Xcel Energy®
RESPONSIBLE BY NATURE™

April 20, 2010

Re: Ashland Lakefront Superfund Site, Ashland, Wisconsin: Additional Comments on EPA's Proposed Plan (June 2009)

Figure 1. Cumulative Distribution Plot of Sediment Concentrations of □ g tPAH/g OC Compared to the Distribution of Biological Effects Responses

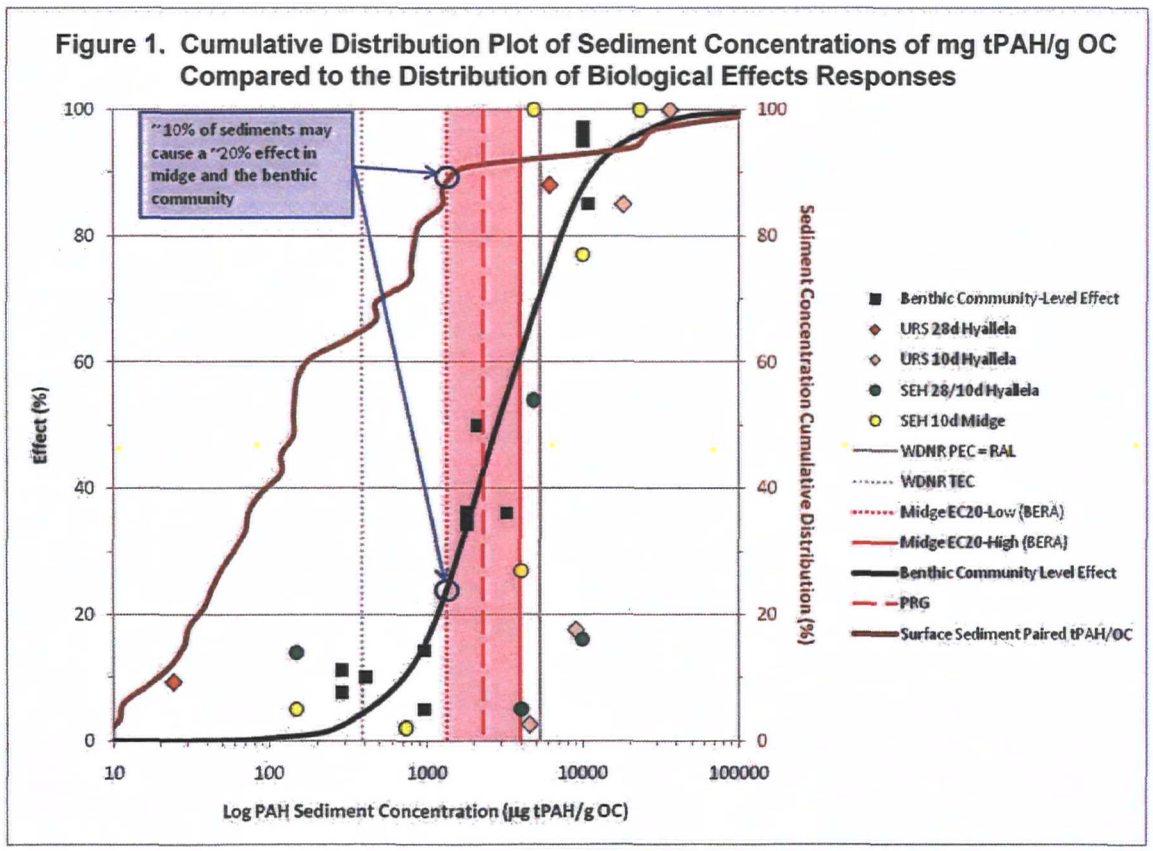
- In this example, there are 75 samples that have both tPAH and organic carbon measurements in the Ashland data compilation for the two embayments. We have also added 6 dummy variable numbers at the low range to demonstrate that concentrations are not "diluted away" and provide a sufficient data distribution to test the approach. These data were used to create 18 composites, each containing 9 samples. These data are placed into a 9X9 grid sample containing cells in both rows and columns. These 81 samples/cells are distributed in the composites equally so that each sample is included in one row and one column of a grid containing the sample data. The data for each row and column composite are averaged. These row and composite means represent SWAC values and are subsequently compared to the 2,295 μg tPAH/g OC (Figure 1).

samples having concentrations less than a particular value (Figure 1). This distribution of data is included on a chart with the toxicity information so that they can be referenced at the same time. The mid-point of the low range of the distribution was designated as the reference or background concentrations (~400-500 μg tPAH/g OC). We used this value compared to the EPA proposed maximum RAL (5,324 μg tPAH/g OC) to determine the acceptable composite value which is 10. The samples were divided into groups of 9 to provide a composite number of samples <10.
